Illustrated Parts List - IPL Update

565

STARTER

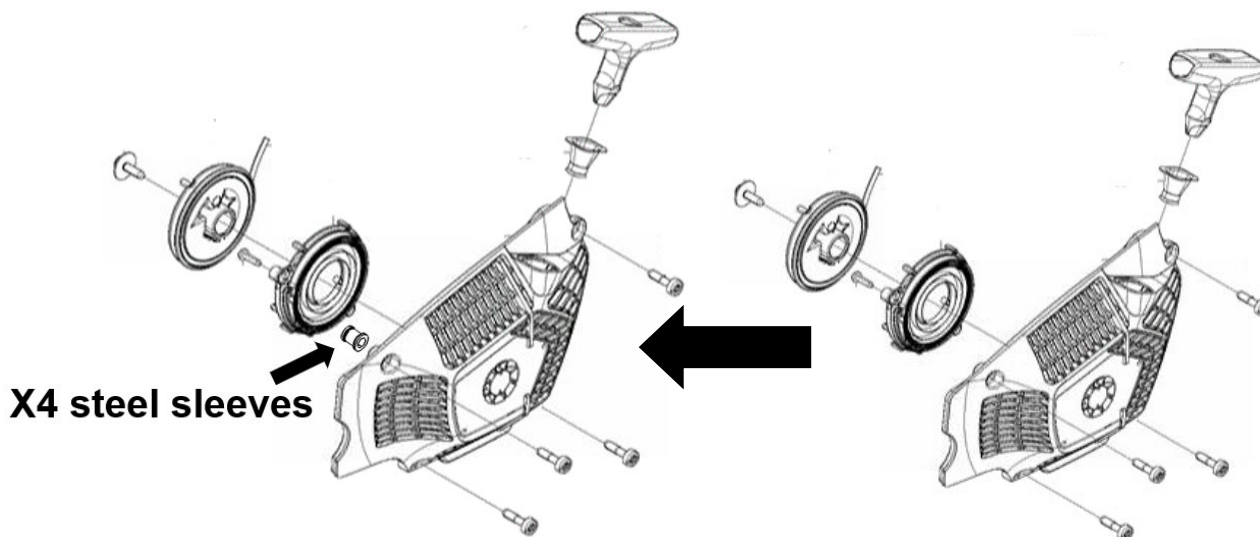
New Starter housing with four steel sleeves added. Increased screw torque to 6Nm (was 4Nm).

Reason: Better fastening of starter housing in crank case.

New article 575 52 76-04 Starter housing assy is fully interchangeable.

New article 575 52 58-02 Starter housing is fully interchangeable.
